RE: Application for Sign Permit
1101 W. University Dr. Rochester Hills, MI
HENRY FORD HEALTH

We are in receipt of your applications for multiple sign permits for the above-referenced location. However, some of your applications do not meet the requirements as set forth in our Ordinance for the following reason(s):

**HENRY
FORD
HEALTH**

E43 SITE PLAN & SETBACKS

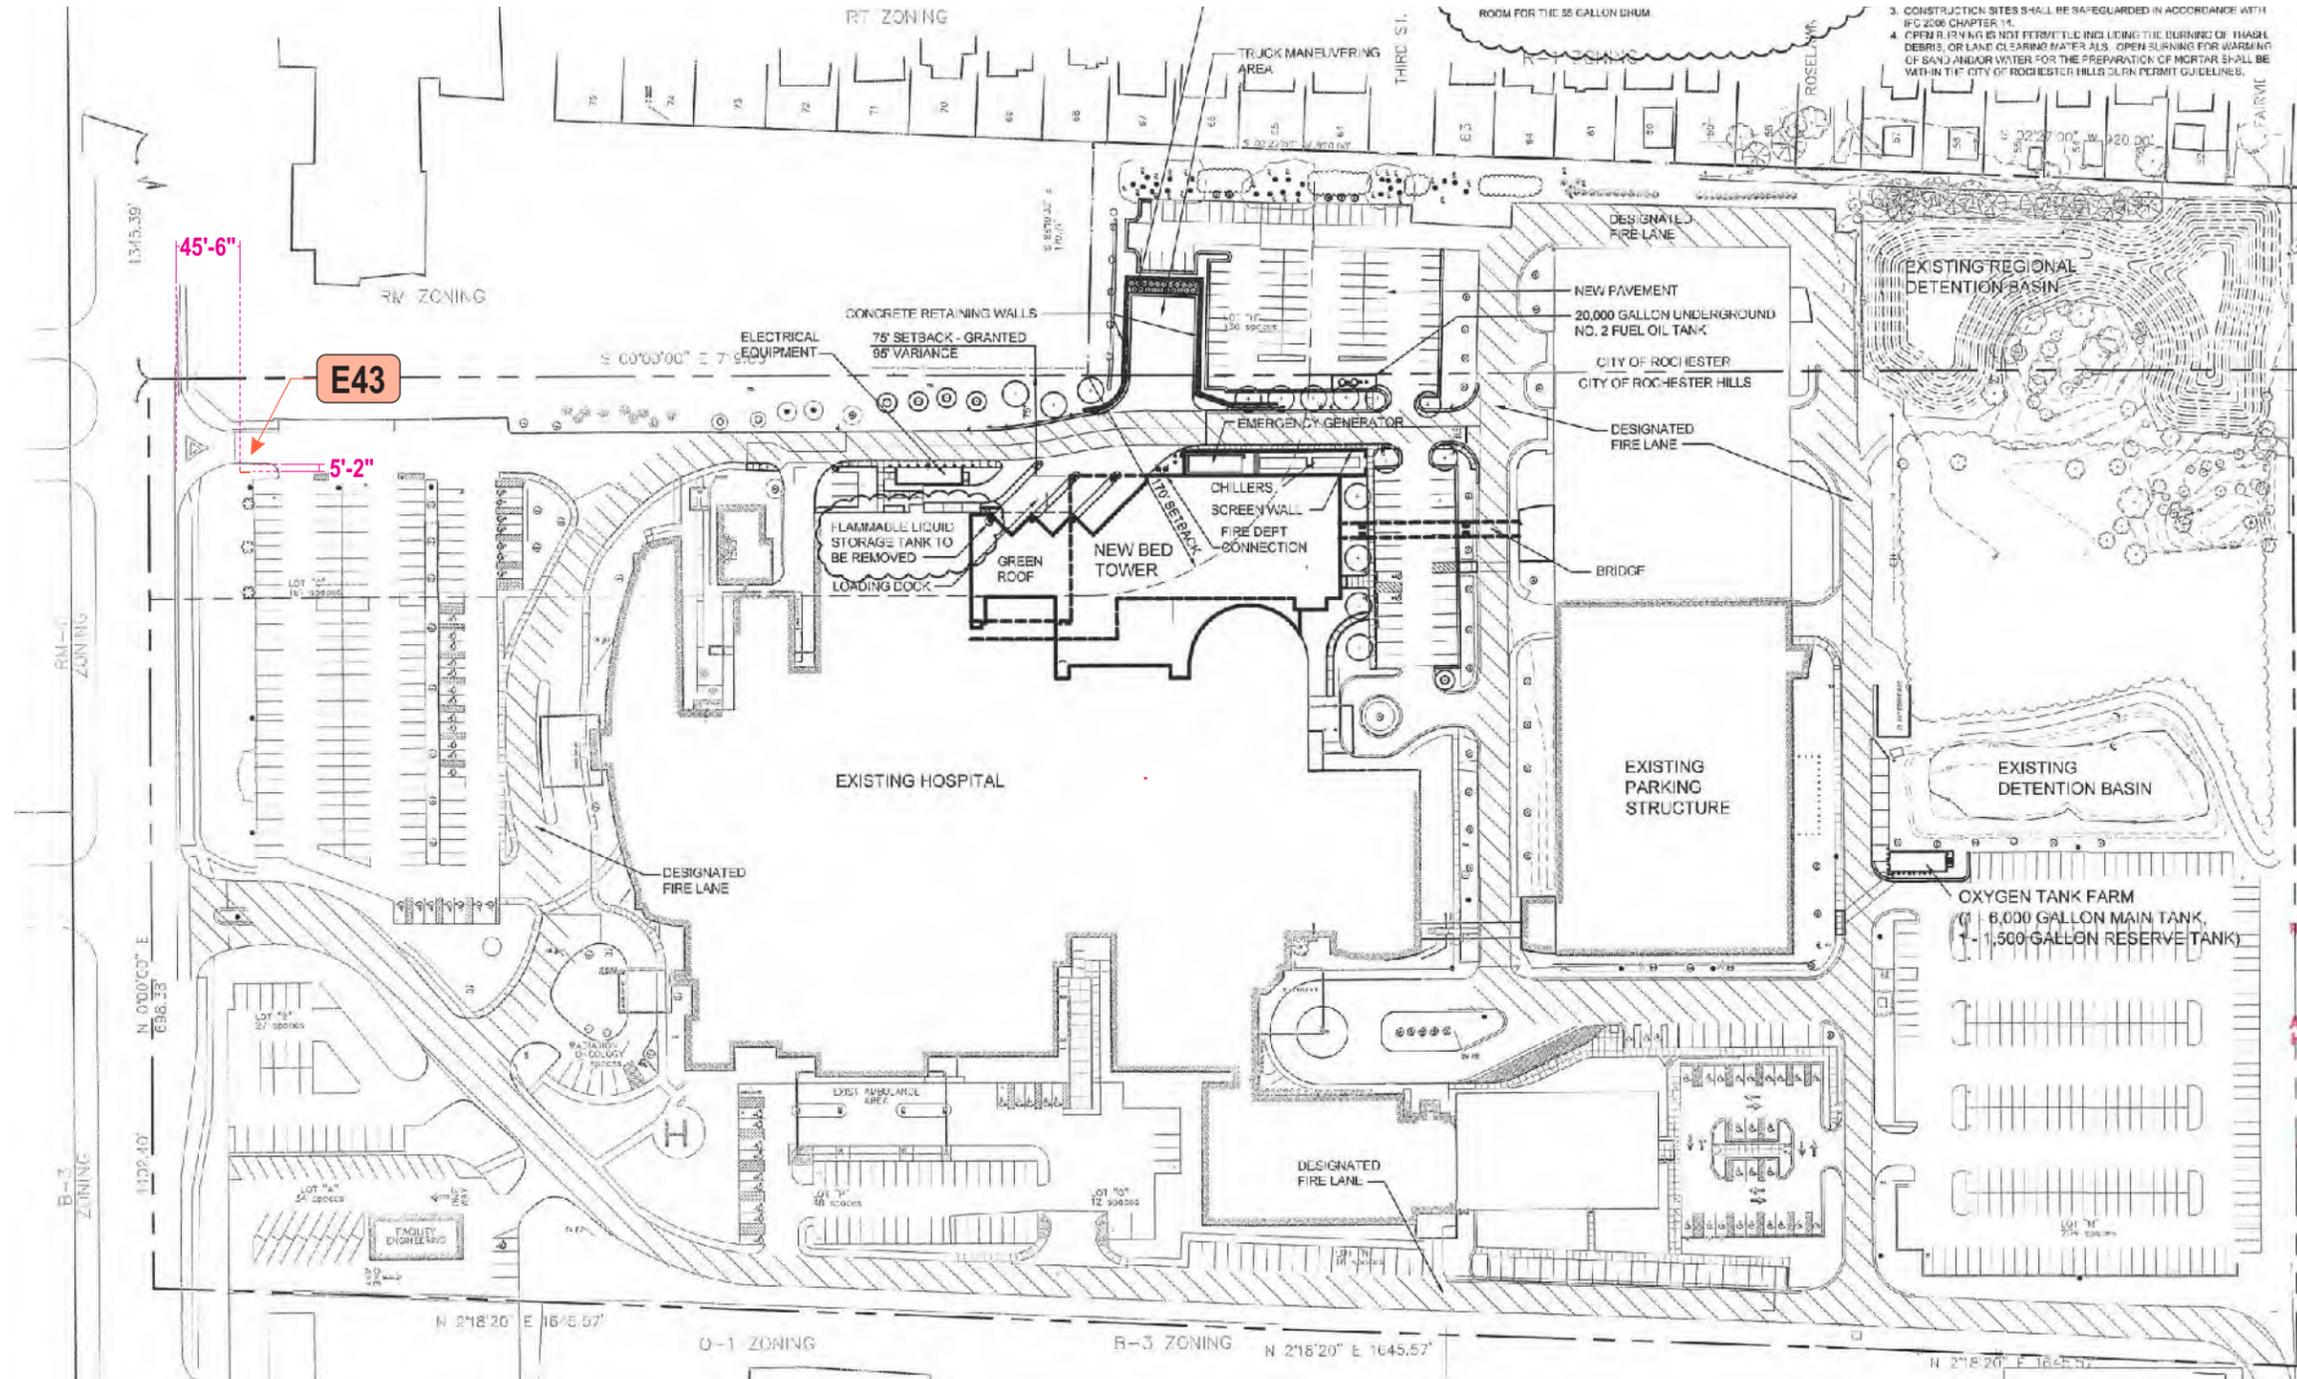
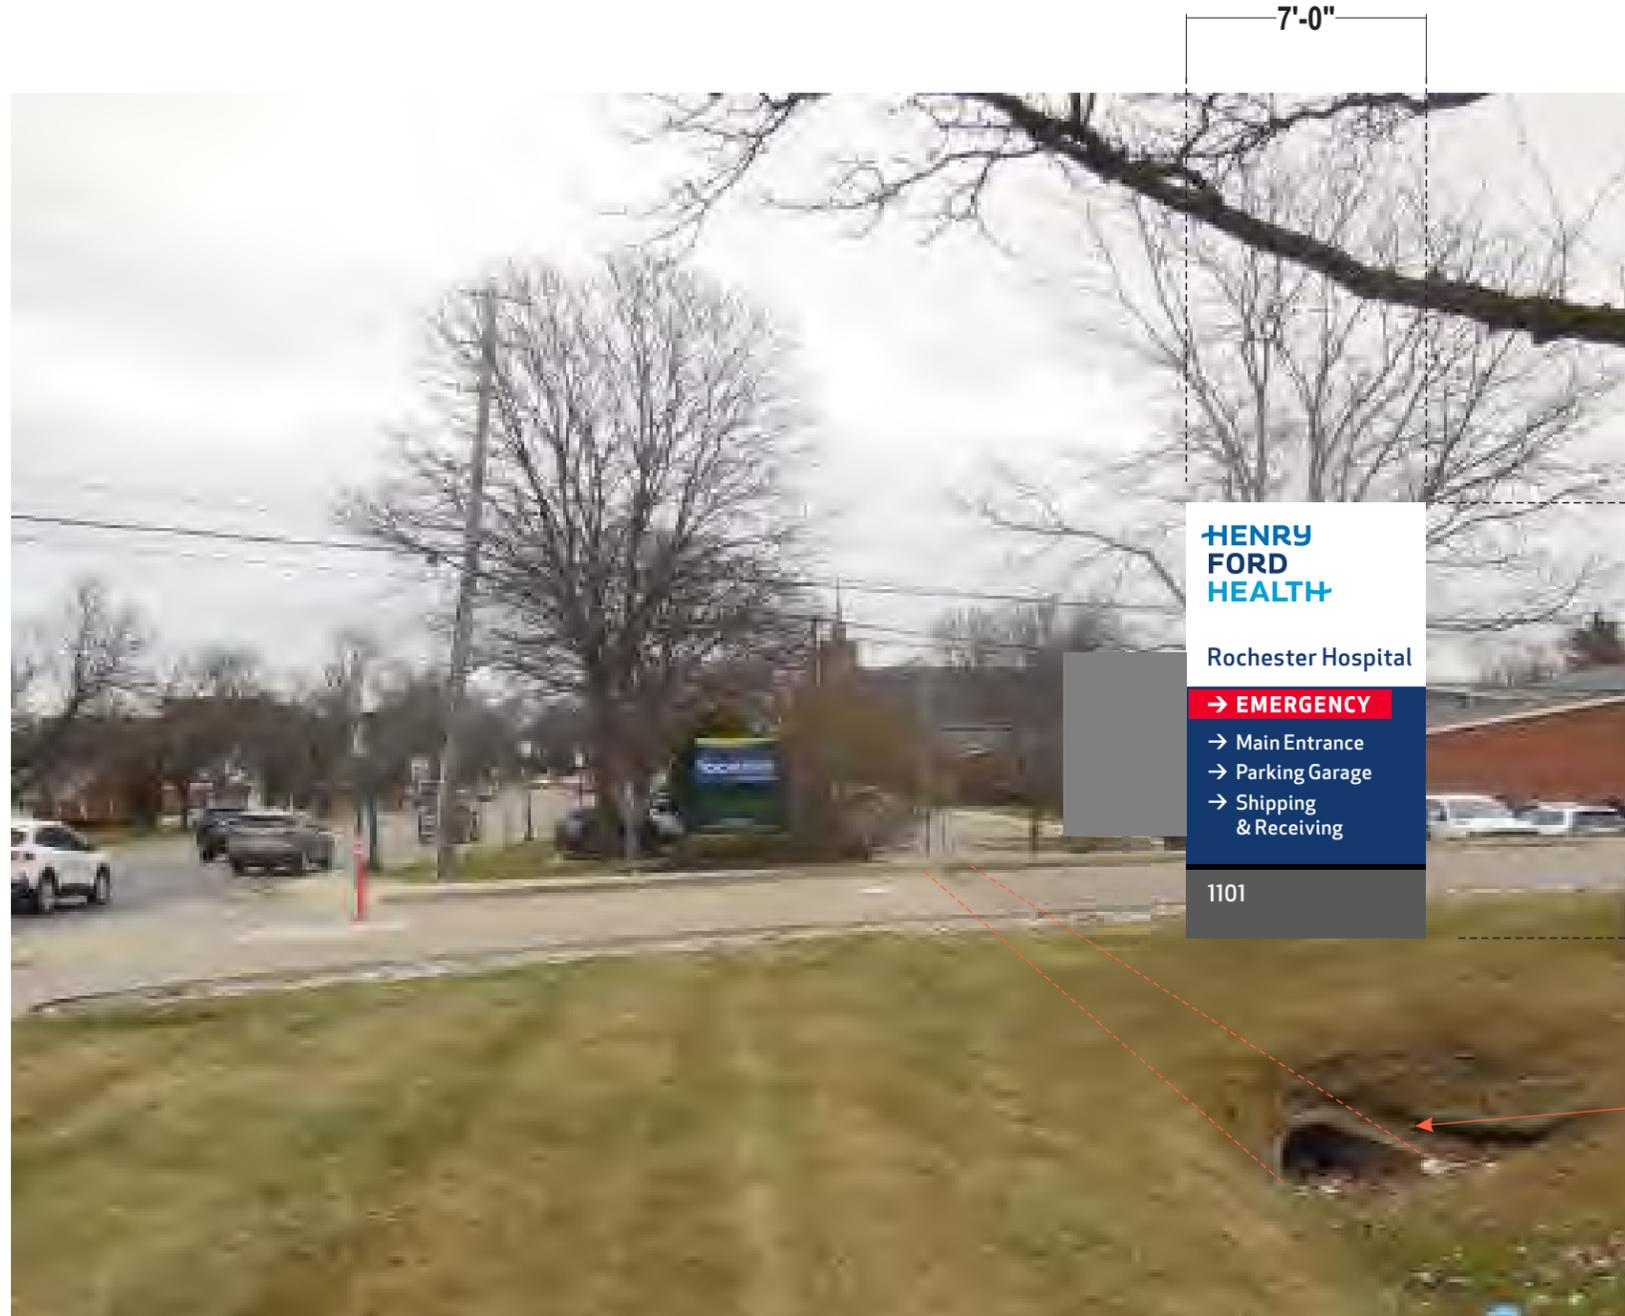
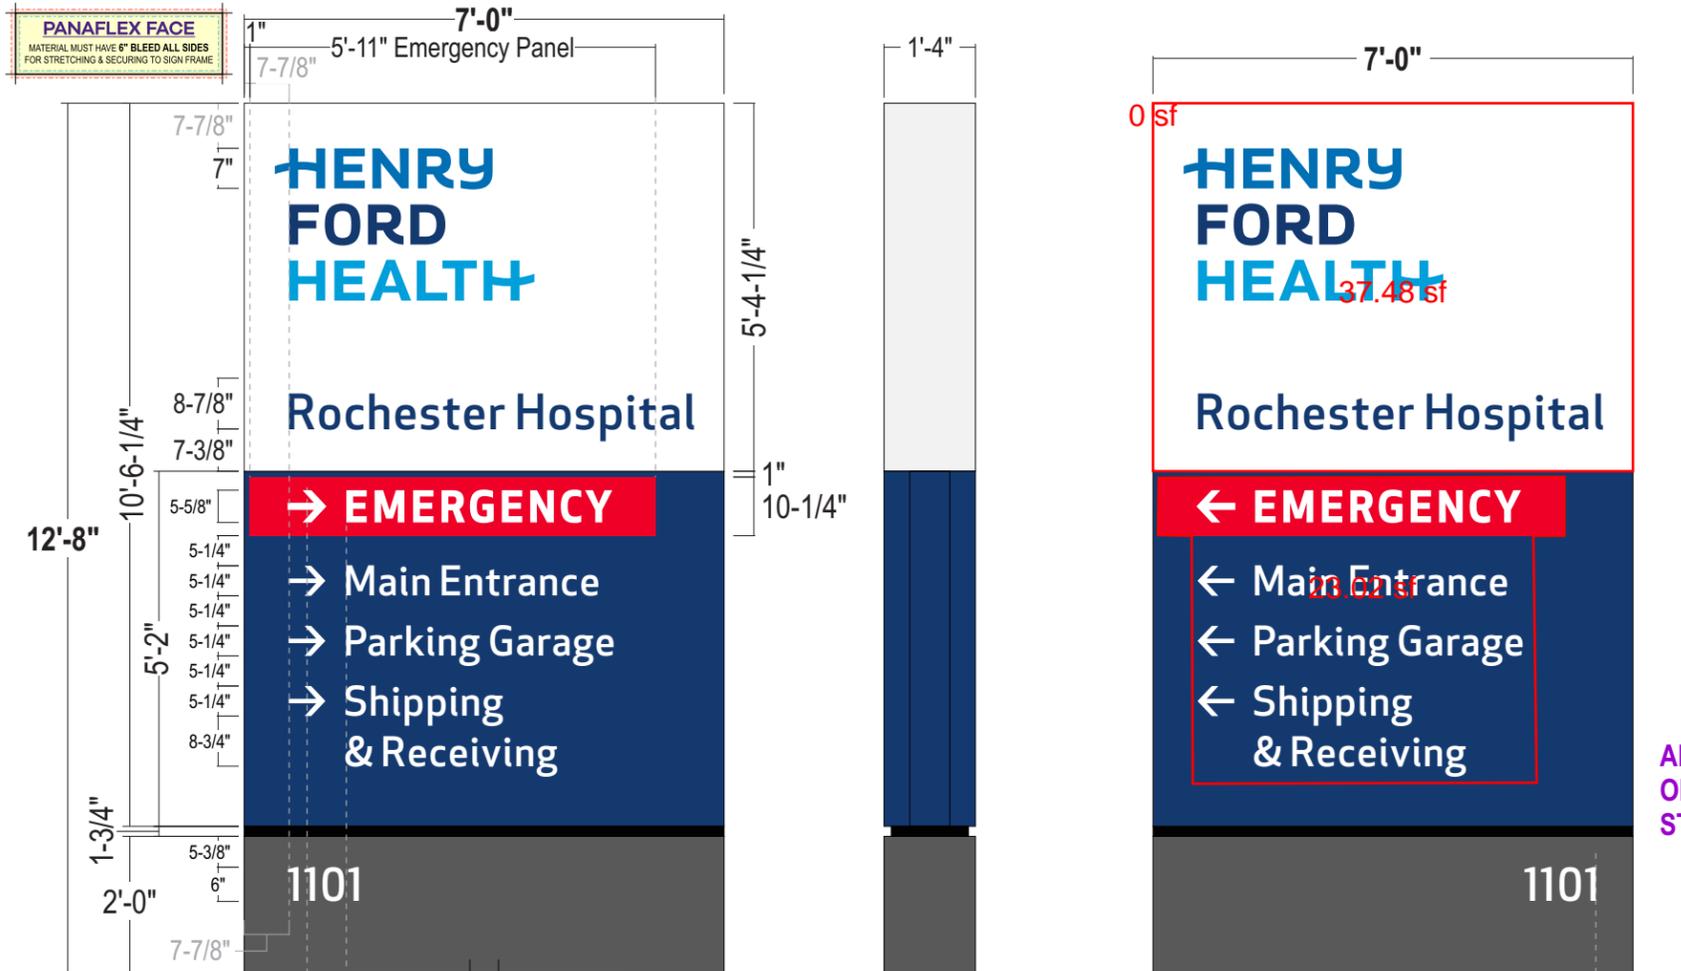
Sign E43 - Monument sign replacement with new footing. The proposed sign is 60.5 square feet (measured around the top illuminated panel and illuminated copy on the bottom panel; address is not included), and a proposed height of 12.67 feet.

The proposed monument sign height of 12.67 feet for Sign E14 and Sign E43 are in violation of the maximum height by 5.67 feet.
